Technical News 166

March 2016

Description: Crankshaft Position Sensor/Ignition Pick Up

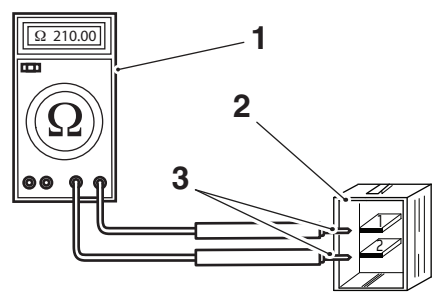
The crankshaft position sensor/ignition pick up is tested using an ohms meter.

To check the internal resistance of the sensor:

- Disconnect and isolate the sensor’s electrical connector from the wiring harness;
- Set the multimeter to ohms;
- Touch one probe to one electrical terminal of the sensor, the other to the remaining electrical terminal;
- Note the reading on the instrument;
- Compare with the resistance shown in the specification table.

Parts Description	Instruments	Carburettor Models	EFI Models
Crankshaft position sensor/ignition pick up (part number T1290131)	Models with mechanical instruments	530 ohms +/- 10% at 20°C	N/A
Crankshaft position sensor/ignition pick up (part number T1290131)	Models with mechanical instruments	N/A	530 ohms +/- 10% at 20° C
Crankshaft position sensor (part number T1296501)	Models with electronic instruments	N/A	210 ohms +/- 10% at 20°C

Description: Front Brake Hose P-clip

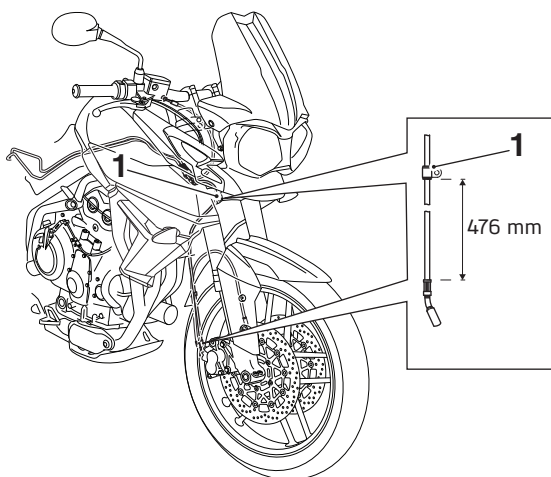
The above models are fitted with a front brake hose secured by a P-clip to the lower yoke.

If removed for any reason the P-clip must be repositioned 476 mm from the edge of the brake hose union.

When fitting a new front brake hose discard the P-clip and secure the brake hose using the pre-positioned clamp supplied with the hose.

Description: Headlight Fixings

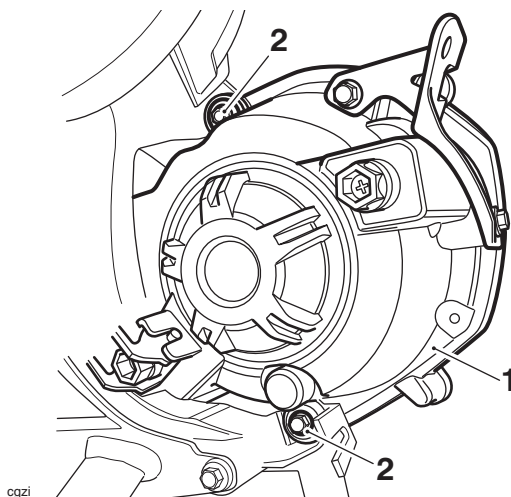
The torque figure for the headlight fixings has changed to **4 Nm** on the above models.

Description: Reed Valve Cover Torque Fixing

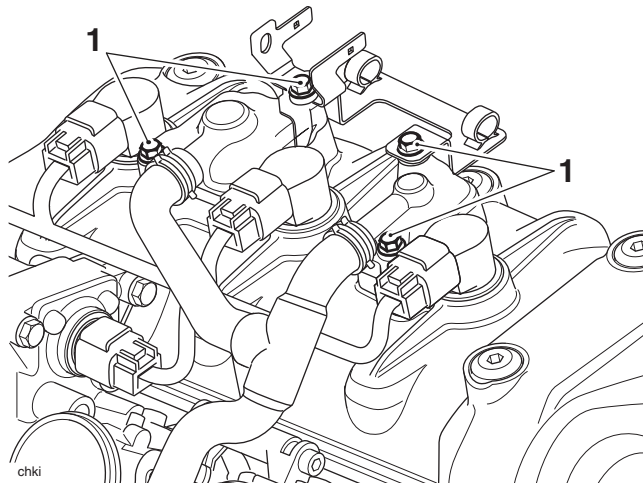
The torque figure for the reed valve cover fixing has changed to **9 Nm** on the above models.

Description: Engine Bar Plugs
Models affected: Tiger XC and Tiger XCa

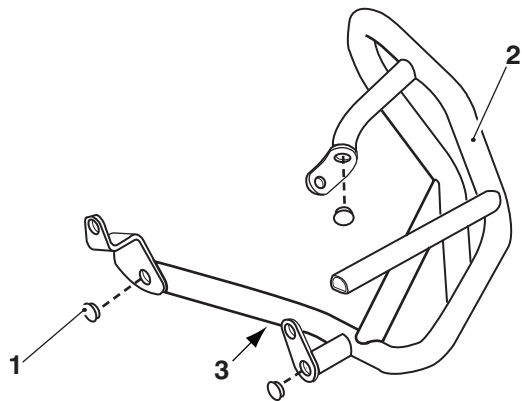
A modification has been introduced to the engine bars fitted to the above models from VIN 737369. Three plugs are fitted to each engine bar and a drain hole has also been introduced. The new engine bars are retrofittable to the above models.

Description: Lower Yoke Wire Guide

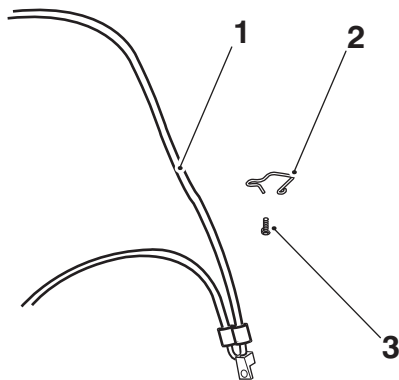
A new lower yoke wire guide has been introduced to the above models from VIN 733650. The new lower yoke wire guide has a modified profile to improve clearance to the radiator guard.

The new lower yoke wire guide is retrofittable to the above models.

The fixing used is the same as the previous lower yoke wire guide and the torque remains at **6 Nm**.

Backrest Bar Installation

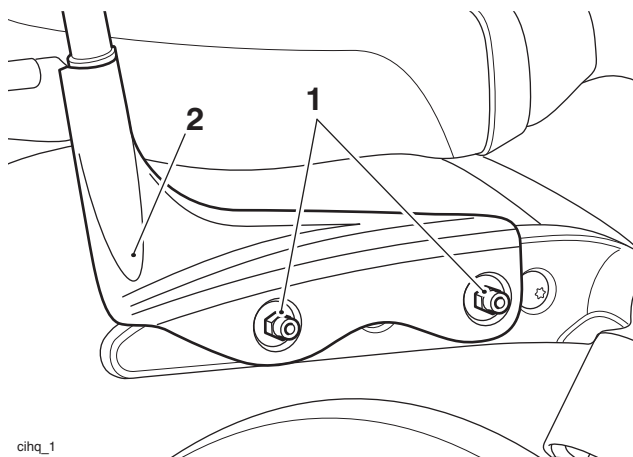
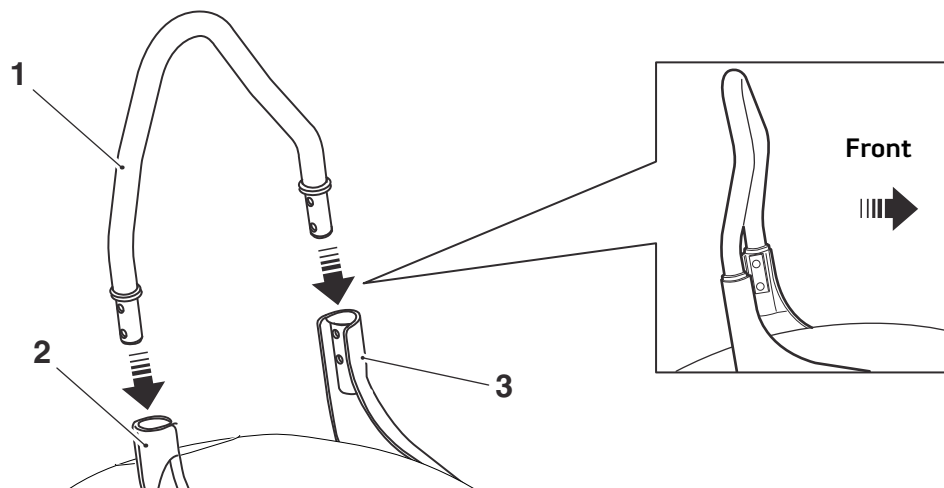
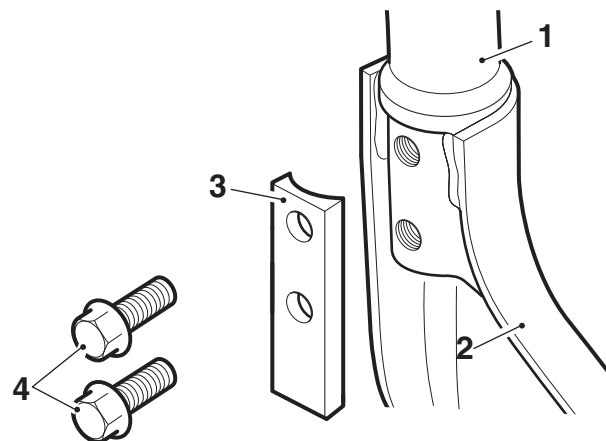
The passenger backrest bar will no longer be factory fitted to the above model from VIN 738585. Instead, the backrest bar, clamp plates and fixings will be provided in the packing crate as part of the parts kit and screw pack.

Dealers will be required to install the backrest bar prior to Pre Delivery Inspection (PDI).

1. Remove the panniers as described in the Service Manual.
2. Loosen the four fixings securing the backrest brackets to the motorcycle. Do not fully remove.

3. Recover the backrest bar and locate it fully into the backrest bar brackets, in the orientation shown below:

4. Recover the clamp plates and the M8 x 25 mm fixings from the screw pack. Position the clamp plate to the backrest bar bracket and secure using the fixings. Do not fully tighten the fixings at this stage.

5. Tighten the four fixings securing the backrest brackets to the motorcycle to **20 Nm**.
6. Tighten the backrest bar fixings to **27 Nm**.
7. Refit the panniers as described in the Service Manual.

Description: Rear Bevel Box Parts Kit

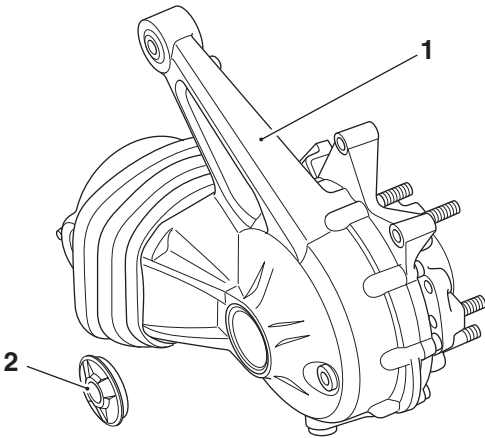
A new rear bevel box assembly incorporating a longer hub shaft has been introduced on the above models from engine number 726747 (UK ONLY) or engine number 737465 (ALL MARKETS EXCEPT UK).

A new cap has also been introduced for use with the new bevel box assembly to accommodate the longer hub shaft.

The new rear bevel box assembly and cap are retrofittable to all earlier engine numbers only when fitted together as part of a kit. To facilitate this, parts kit T1275555 has been released for use with the above models up to engine number 726746 (UK ONLY) or engine number 737464 (ALL MARKETS EXCEPT UK).

Description: Pannier Frame

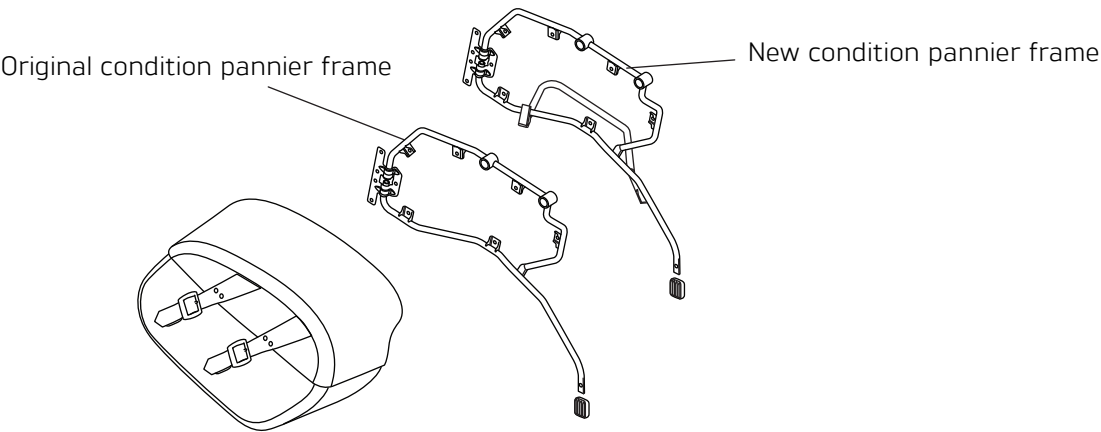
A new pannier frame has been introduced to the above models from VIN 739570. The new frame is retrofittable and the original pannier can be fitted to it.

The difference between the original condition and new condition pannier frame is the addition of a bar to improve pannier support.
